STATEMENT ON THE 2011 DRAFT MURRAY-DARLING BASIN PLAN

The Draft Murray-Darling Basin Plan should be withdrawn because it does not provide the information required to make an informed decision on the future of the river system.

January 2012

INFORMATION IN THE DRAFT PLAN FOR ONLY 4 OF THE 18 KEY ENVIRONMENTAL ASSETS ⁶

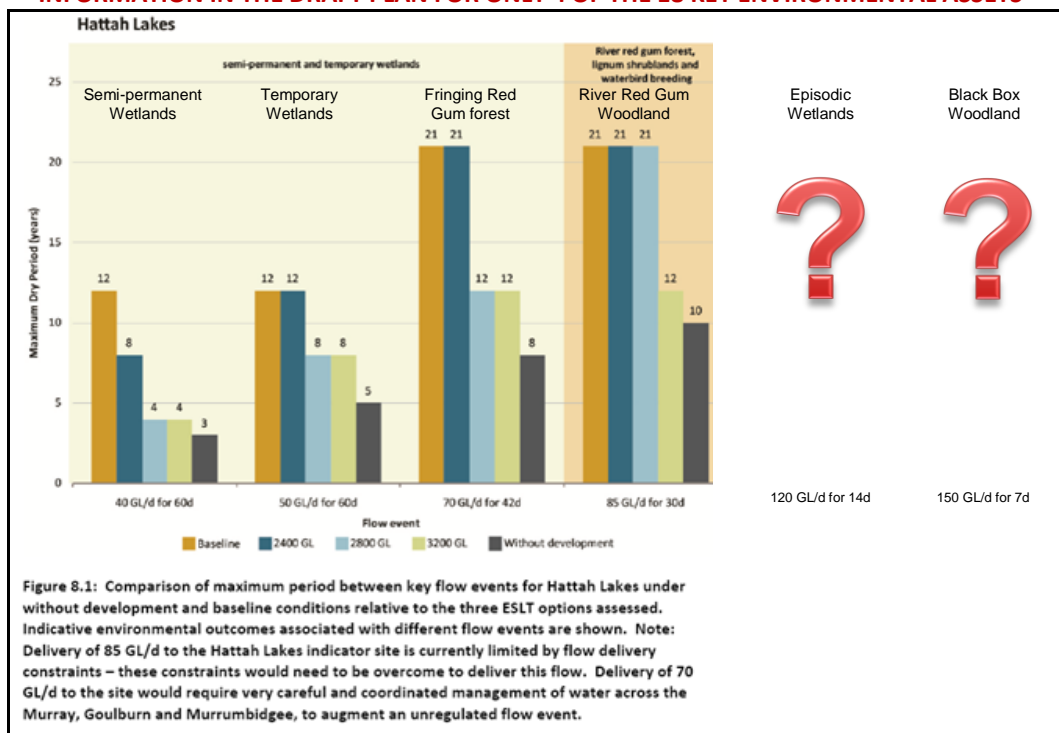
The draft Plan documents for the Hattah Lakes Ramsar site (one of the 4 sites where any information is provided) presents information on only four of the 6 components (Figure 8.1 below):

This information shows that there is a noticeable improvement when the reduction in extractions is increased from 2,400 GL to 2,800 GL for semi-permanent wetlands, temporary wetlands and fringing red gum forest. It also shows that a reduction in extractions of 2,800GL produces no environmental benefits for the river red gum woodlands, and that a reduction of another 400 GL (to 3,200 GL) is required if there is to be any improvement in river red gum woodland communities.

The diagram in the draft Plan hides the fact that a 2,800 GL reduction target will not deliver water onto parts of the floodplain, yet it is these floodplain wetlands and woodlands that drive the ecology of this vast inland river system.

According to the figures in the 2010 Guide, three floodplain components (the River Red Gum woodland, the Episodic wetlands and Black Box woodland) receive no environmental benefit from a 2,750 GL reduction. Two of these three are omitted from the information provided in the draft Plan, presumably because they show that they will not be maintained under the proposed flows.

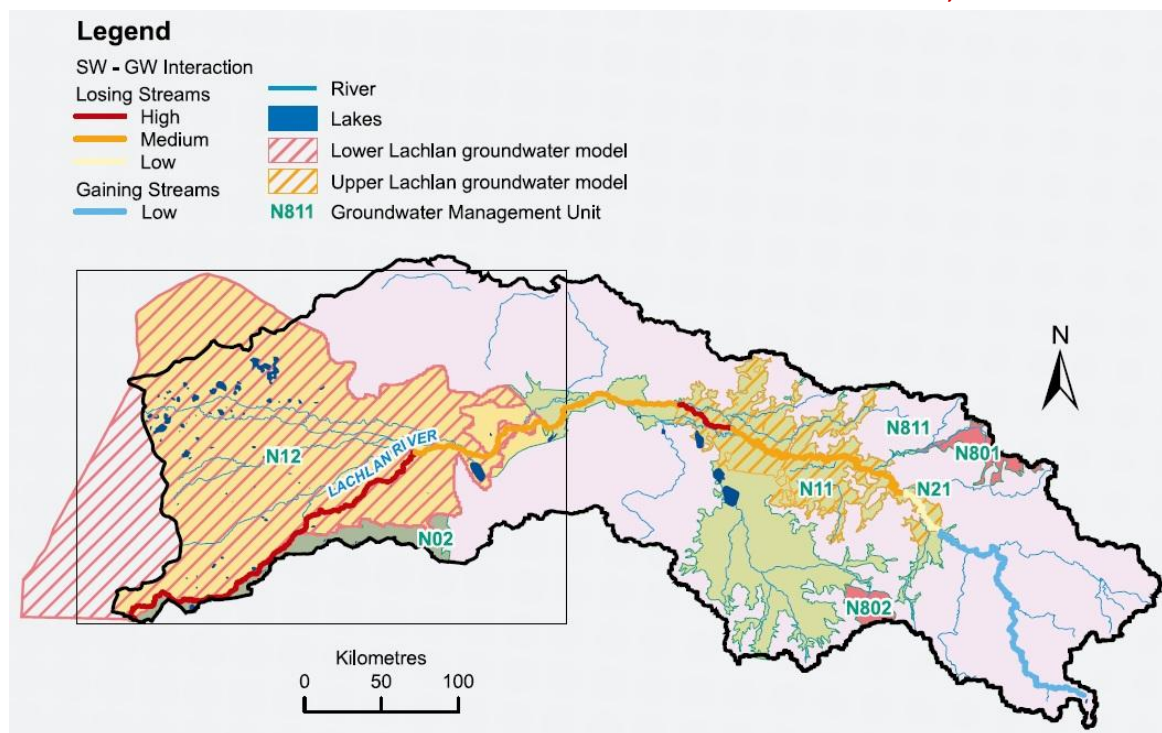
The Lachlan catchment in NSW is an example of the implications of these changes and the likely impact they will have on the long-term health of the basin.

The 2010 Guide proposed reducing the current diversion limit for the Lachlan Alluviums of 185 GL to 128 GL (a reduction of 57 GL).

You can only use the water once. If you take the groundwater from these aquifers you will lose surface water, because there is a high level of connectivity between the alluvial aquifers and the river as shown in the figure below.

The lack of analysis of the connectivity and the impacts on Sustainable Diversion Limits (SDLs) in the draft Basin Plan make it impossible to assess the appropriateness of both the groundwater and surface water SDLs presented in the plan.

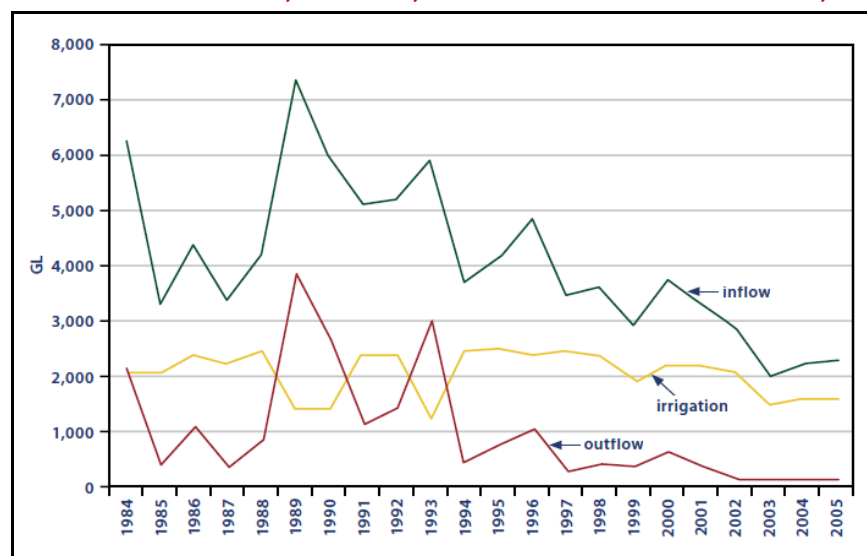
The draft Plan does not take into account the risks of reductions in environmental flows and the likely adverse impacts of climate change on river health when it set the 2,750 GL recovery figure.

This is quite extraordinary. The CSIRO Sustainable Yields project was commissioned by the government to provide the basic information on the Basin. It was specifically asked to assess the effects of climate change on water availability. We know that the CSIRO modelling suggests that climate change is likely to result in significant reductions in rainfall and runoff in south-eastern Australia over the next 20 years. Yet the draft plan ignores these effects even though it is intended to guide water use in the basin over much of the same time period.

We have seen how these existing rules impact on the environment when southern weather systems return to a drier cycle.²⁰ The figure below shows the levels of inflows, outflows and water used for irrigation for the Murrumbidgee River. Between 1994 and 2005, the outflows from this river to the Murray have been negligible, while at the same time, irrigation use has remained above 1,500 GL.
